CALIFORNIA COASTAL COMMISSION

COASTAL DEVELOPMENT PERMIT APPLICATION REGULAR CALENDAR

Application number 3-00-082

Project description Demolition of the remnants of a 392 sq.ft. single family dwelling destroyed by fallen tree in 1995 winter storm and construction of an approximately 1,196 sq.ft., two story single family dwelling on a steep sloping 3,629 sq.ft. lot. See Exhibit 2.

Project Site Plan

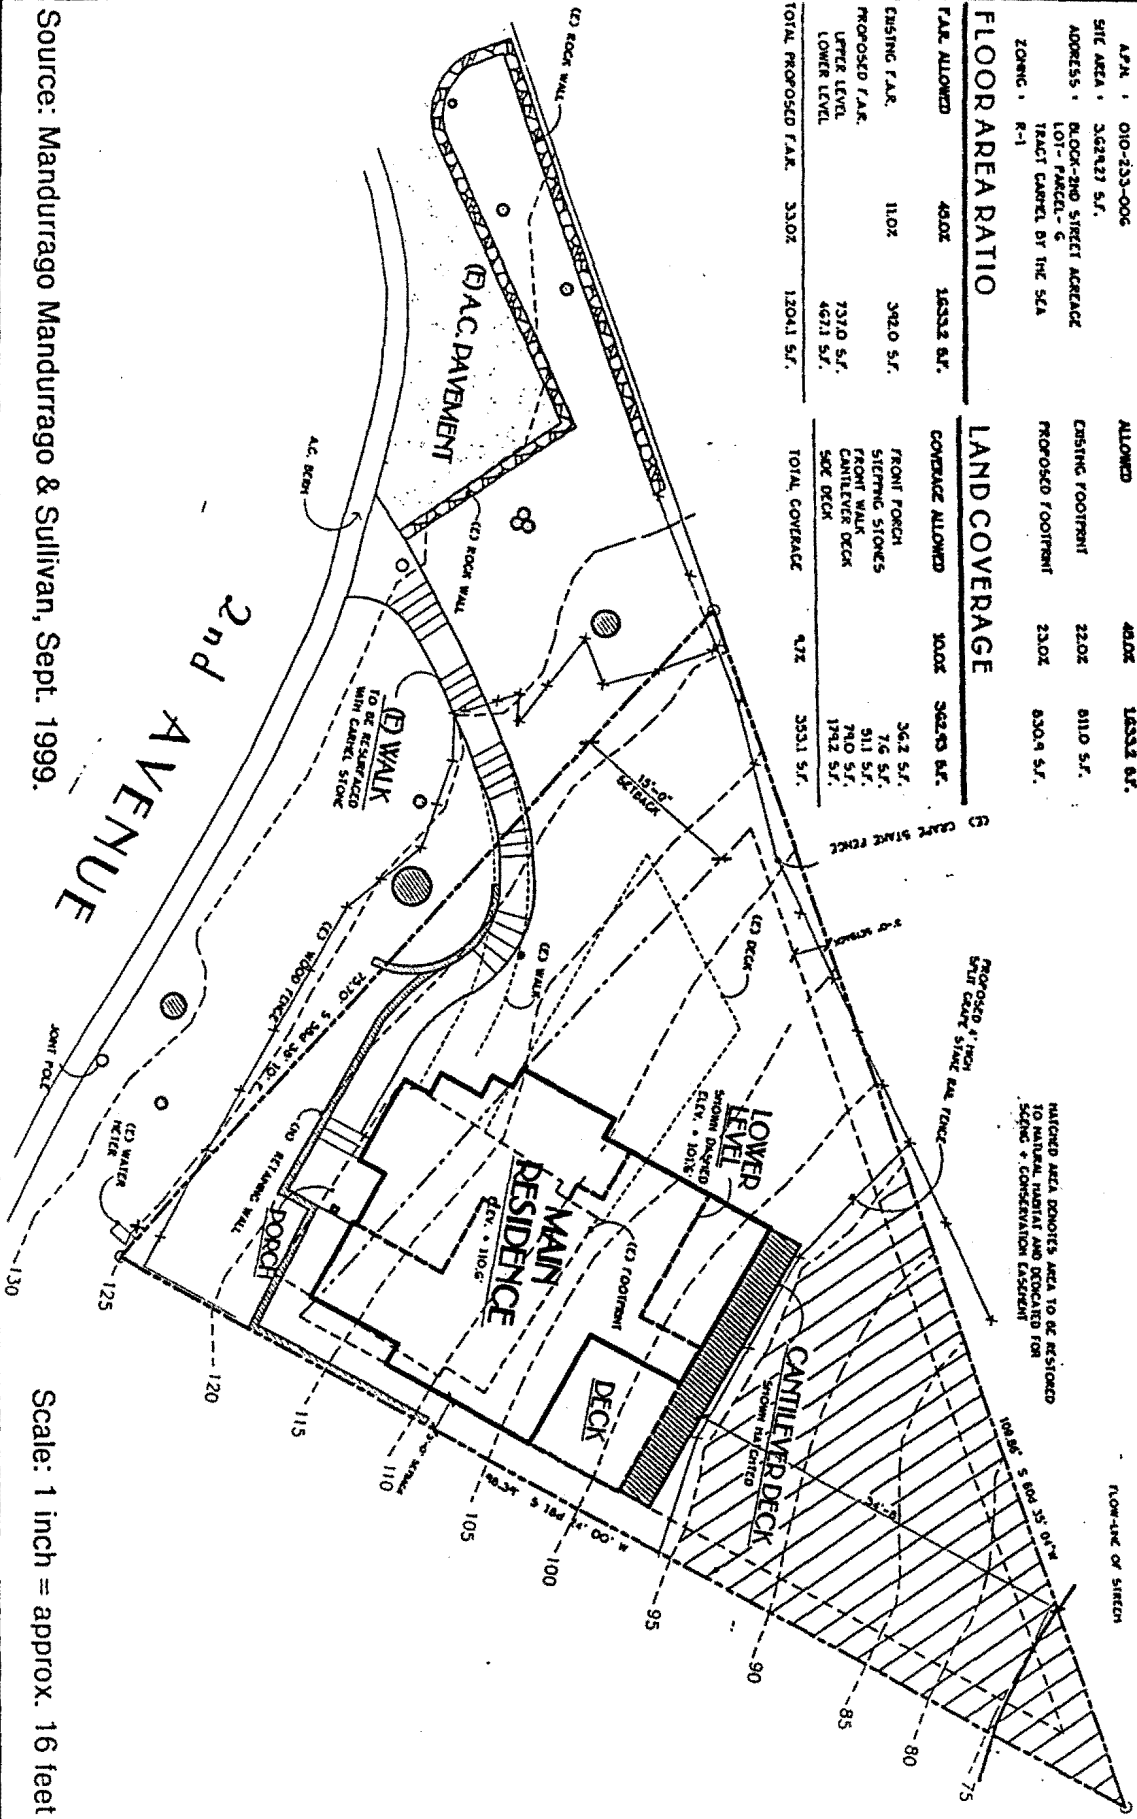
Applicant proposes to replace the remnants of the demolished small home with a structure that is significantly larger and located to within 31 feet of Pescadero Creek within the riparian corridor. The previous small home was setback 50'. The proposed project would not only result in temporary construction impacts, but also result in long-range cumulative impacts by reducing the available area for the growth of riparian vegetation and native Monterey pine forest. In addition to directly removing ESHA for home development, the project would encroach on the available wildlife corridor along Pescadero Creek and would introduce an intensified urban use within the ESHA.

The proposed development is for an approximately 1,196 square foot single-family dwelling and includes a 353 square foot walkway and deck. This project will require 240+ cubic yards of grading

and will result in a permanent loss (i.e., site coverage) of an additional 410 square feet of environmentally sensitive habitat. It would be located to within 31' of Pescadero Creek.

EXHIBIT NO. 8
APPLICATION NO. 3-00-082
Digital Photo Simulation
California Coastal Commission

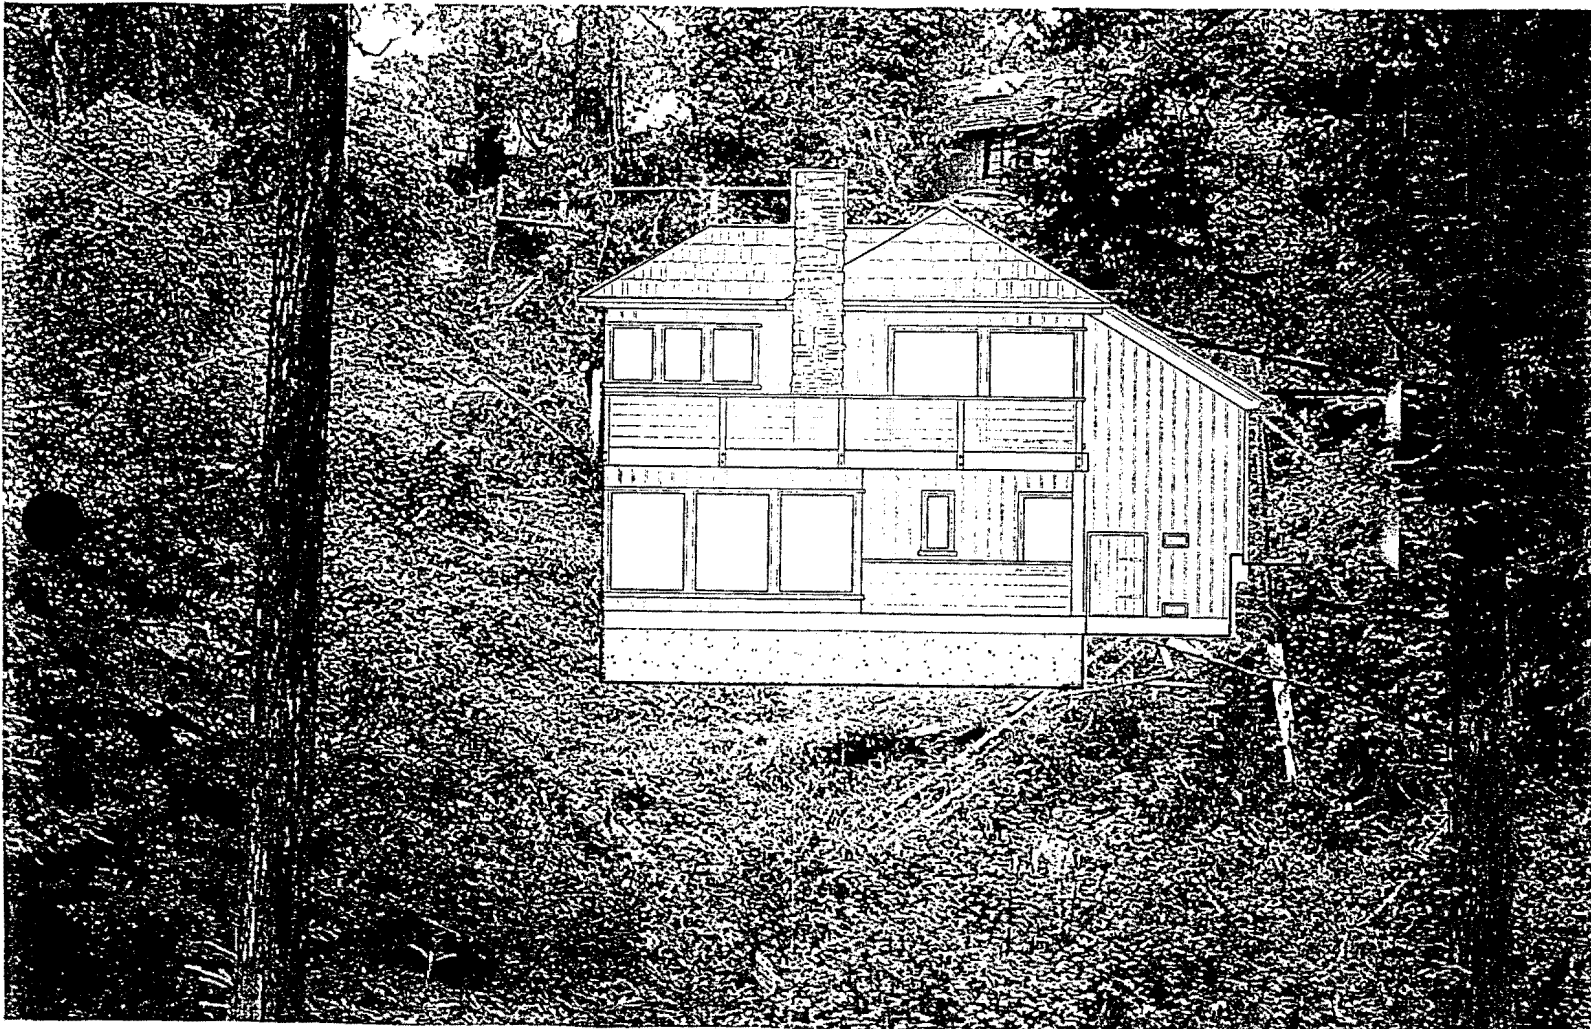
drive, but has not exacted a toll for pedestrian access. The trail network is illustrated in the Del Monte Forest Land Use Plan as part of Monterey County's Local Coastal Plan. The originally constructed trail had elaborate rockwork and was very popular with equestrians, but presently is increasingly in a state of disrepair. In time, we might look forward to the trail being rehabilitated as a link in the California Coastal Trail system. The house as it previously existed was visible from the Redondo Trail. The proposed new structure can also be expected to be in view, but because of its additional size and its current proposed location (31' from Pescadero Creek), would have a more significant impact on the trail user experience (Exhibit 8).

Revised Plans

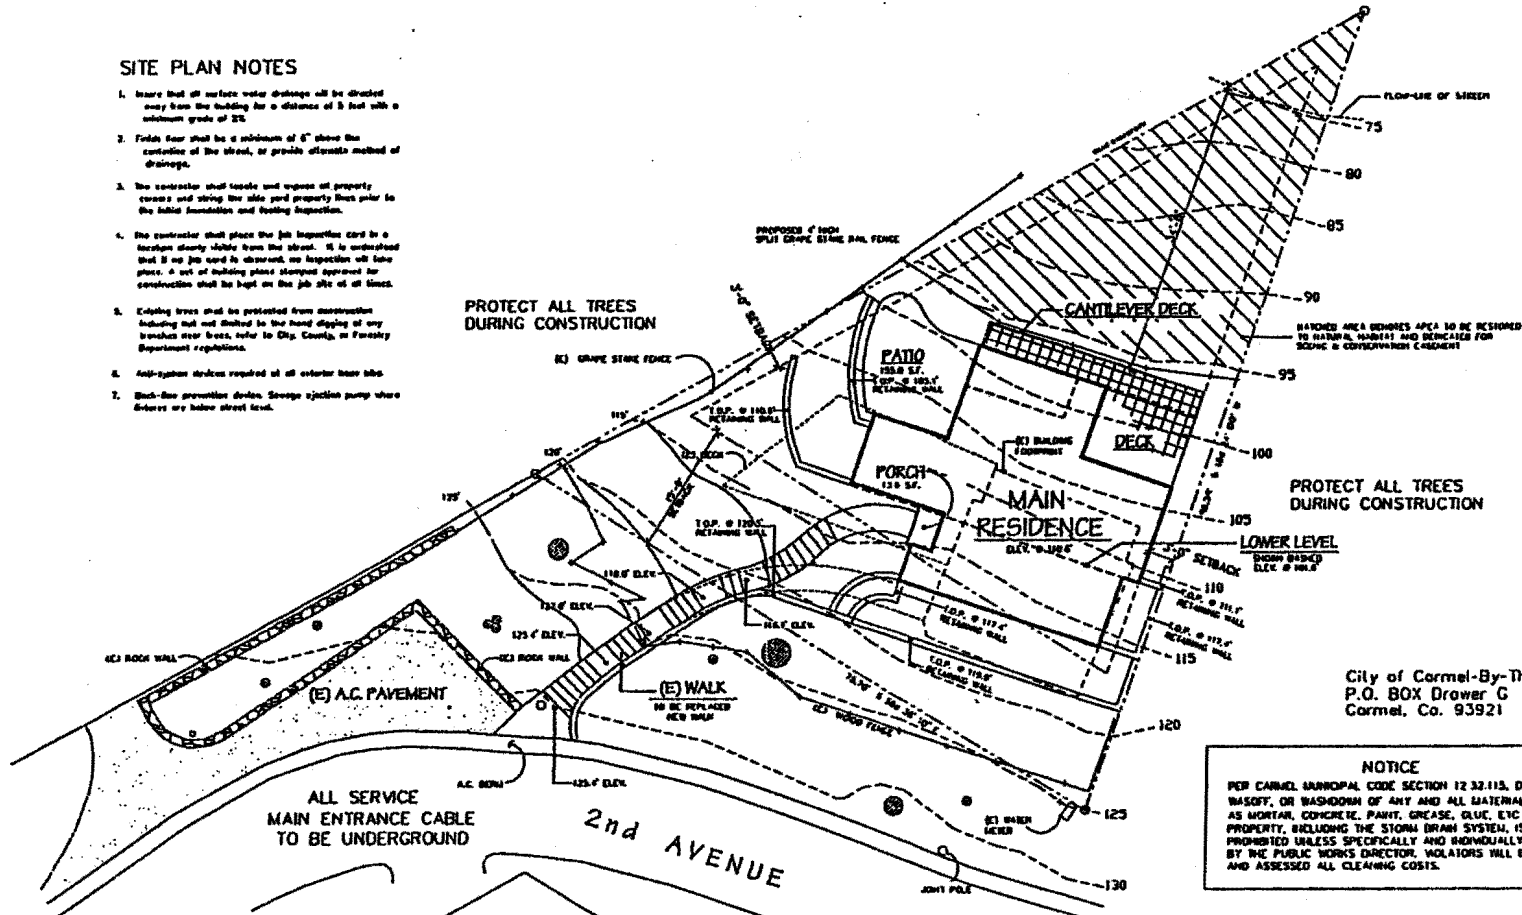
Staff Note: The public hearing on this project was opened at the October 11, 2001 Commission Meeting in San Diego. The Commission continued the item pending review of newly submitted materials and responses to outstanding questions on the proposed project. The applicant submitted revised project plans and elevations at the October meeting. The effect of the revisions are to re-site the structure an additional 3' further down the canyon and closer to the stream below, elongate the east-west building lines, and reduce the overall building height by 3 inches. The applicant claims that the changes will result in a 30% reduction in grading. However, staff was unable to confirm this reduction because the applicant did not submit a revised cut and fill plan, nor was a revised cut and fill plan approved by the City of Carmel. Thus, although it appears that grading may in fact be reduced by the proposed revision, it is the original cut and fill plan that has
